VIRGIL C. SUMMER STATION

TECHNICAL SPECIFICATION 3.2.3

MISCELLANEOUS CORRECTIONS

TECHNICAL SPECIFICATIONS

Figure 3.2-4 Rod Bow Penalty as a Function of Burnup

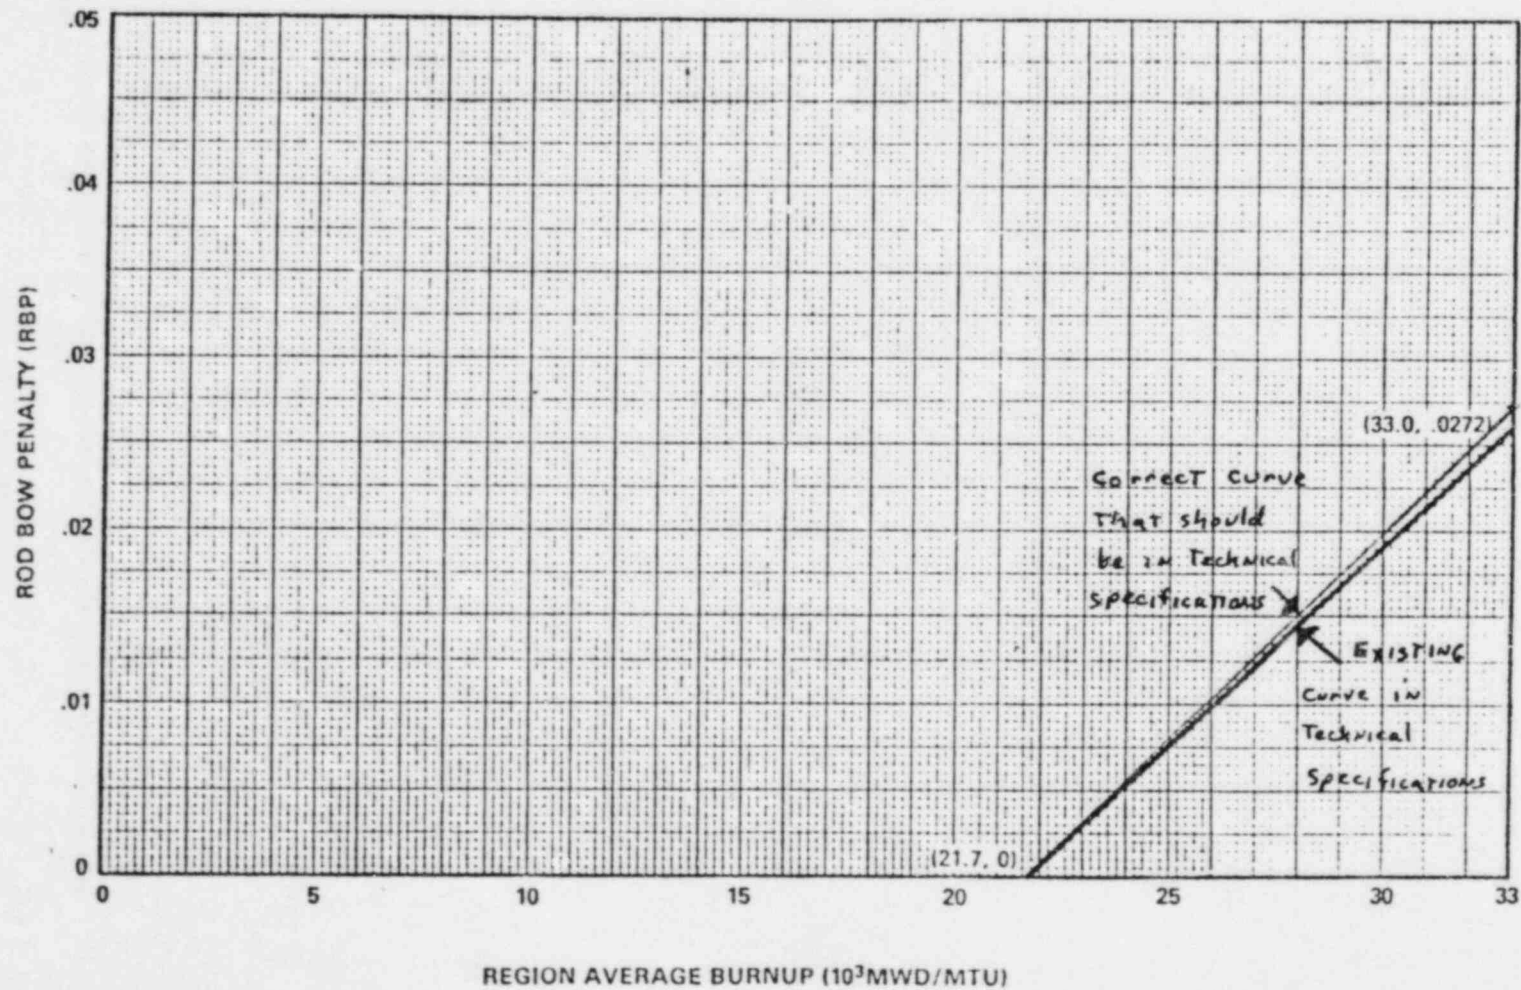
<u>PAGE</u>	<u>EXPLANATION</u>
3/4 2-11	The rod bow penalty curve is plotted incorrectly. The coordinate points are correct.
3/4 4-5	The number for this Specification should be 3.4.1.4.1.
3/4 8-18	Typographical error. Test setpoints for all three reactor coolant pump breakers are the same, 3960 amps.
3/4 9-9	ALTERATIONS -misspelled.
6-3	Typographical error. The correct title is Emergency Coordinator. Also AMD should be ADM as shown.
